MUNICIPALITY OF ANCHORAGE  
MEMORANDUM

DATE: April 9, 2018  
TO: Planning and Zoning Commission  
THRU: *pu* Dave Whitfield, Current Planning Division Manager  
FROM: Shawn Odell, Senior Planner  
SUBJECT: Case 2017-0124, Supplemental Information for Nordstrom Rack

**Subject: Submittal of Additional Information  
Concerning Case "2017-0124", Nordstrom Rack**

# RIM EXHIBIT B (2 of 4)

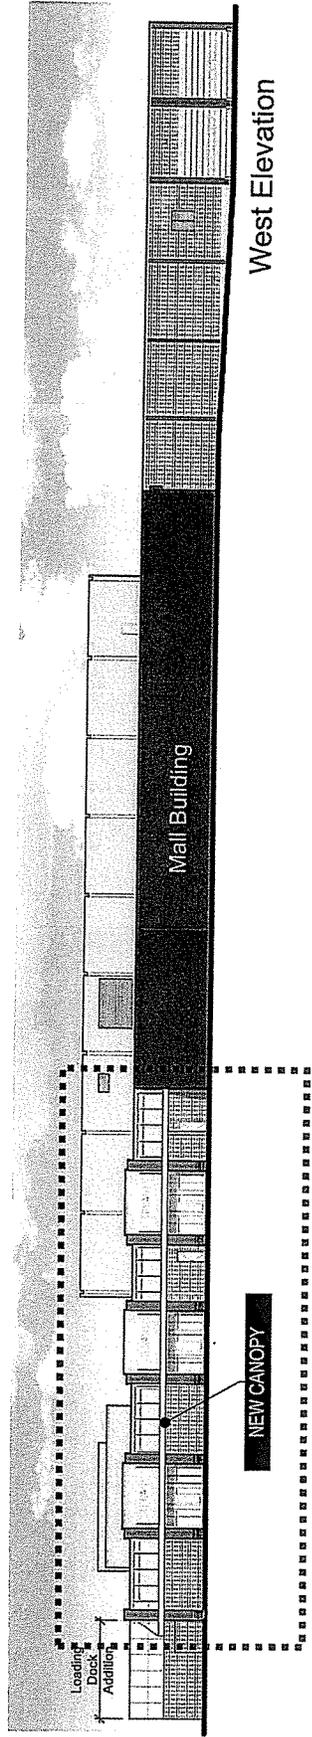
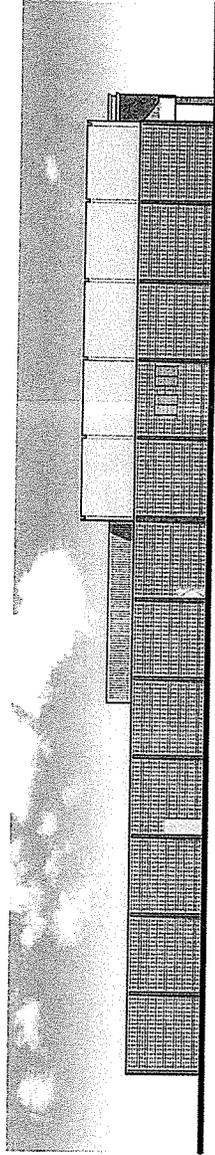
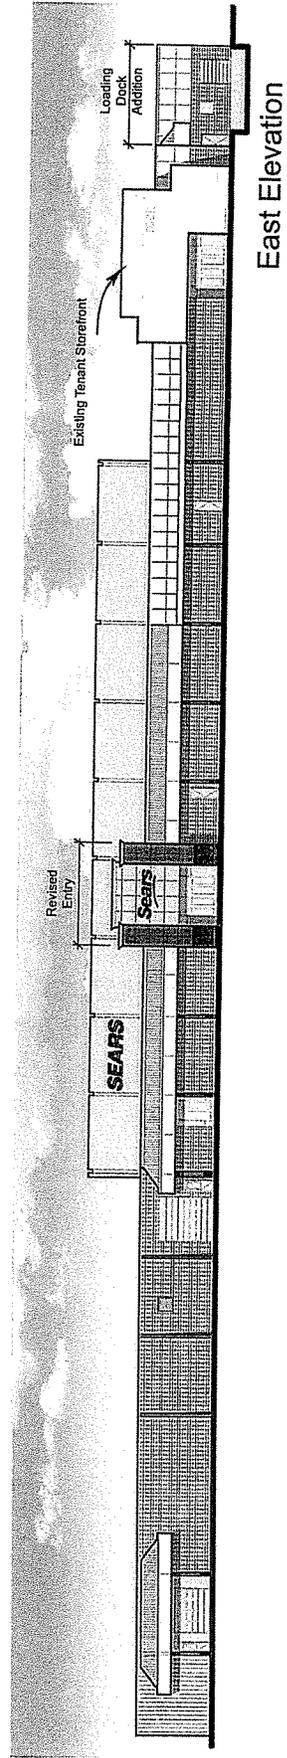
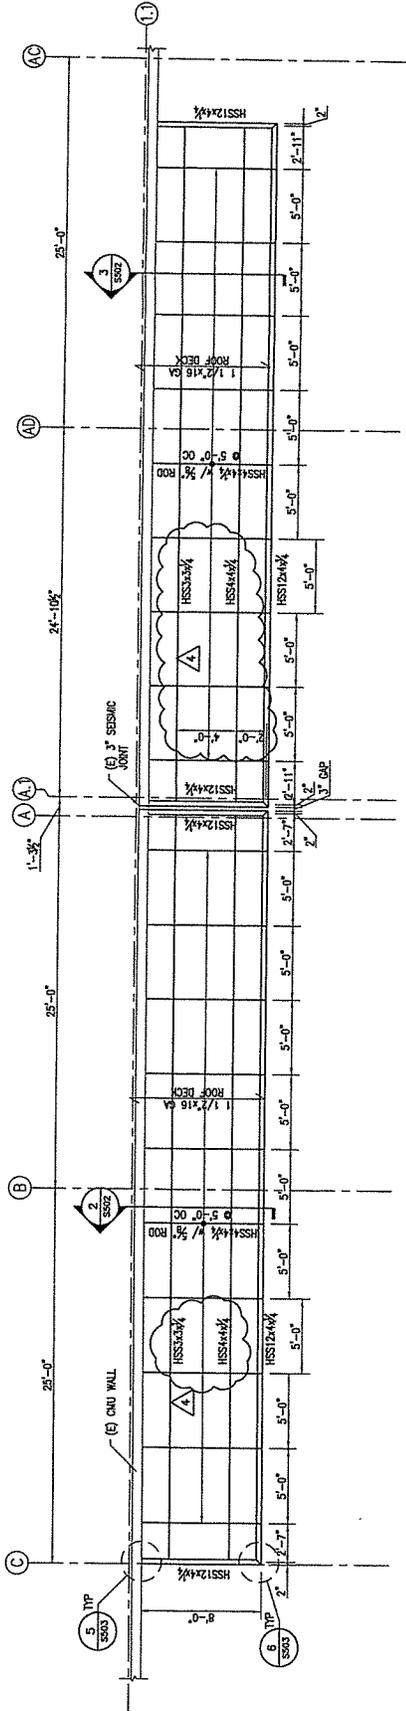
First, and reflecting work that has already been completed, is the parking lot landscaping (interior and perimeter) to the north of Nordstrom Rack related work, as well as additional parking lot lighting improvements just east of the Nordstrom Rack entry area (see Exhibit A). Second, Seritage and the design team identified the west face of the old Sears building, north of the Mall to be an area that would be greatly enhanced if an awning/pedestrian canopy was constructed, providing a covered walkway extending from the adjacent Mall entry, north along the full west face of the new storefront and wrapping around to the north face (See Exhibit B). This would benefit the project in several ways:

Additionally, as approved, a series of arched pedestrian scale lights will be added to the top of the loading dock screening wall, to provide lighting, architectural scale and emphasize to vehicular traffic that the well-lit elevated sidewalk, adjacent to the screening wall is a pedestrian route (See Exhibit C).

1 NEW CANOPY PLAN  
1/4" = 1'-0"

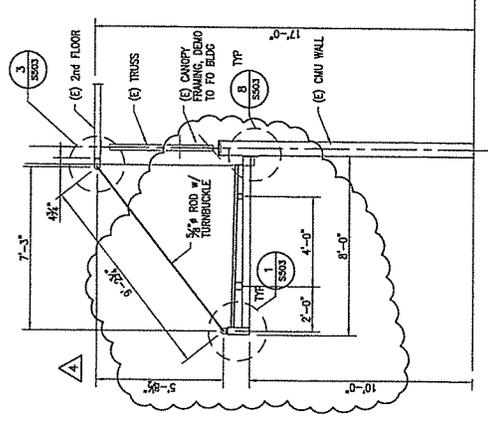
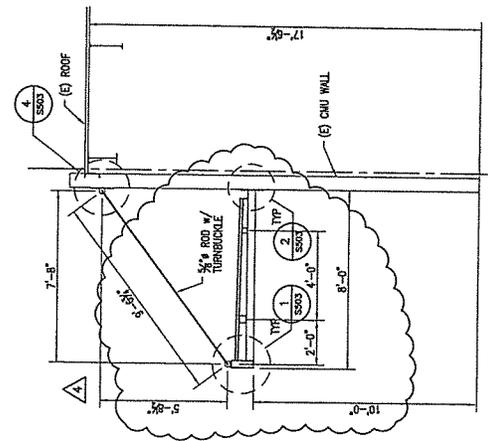
- ◆ Replace and expand upon the limited canopy that was demolished.
- ◆ Provide a weather-protected walkway along the full west face, north of the Mall, which is a heavily used ADA-designated parking area.
- ◆ Provide an exterior covered walkway to the start of the exterior walkway, approved previously, to route pedestrians around the north side of the Nordstrom Rack loading dock.

The proposed canopy, not only makes the walkway safer by providing weather protection, it adds a human scale aspect to the building face and the down lighting incorporated into the canopy will add to the safety and create visual enhancement to the west building face. The new lighting on the screening wall will also add to the aesthetics as the lights wash the screening wall with light.
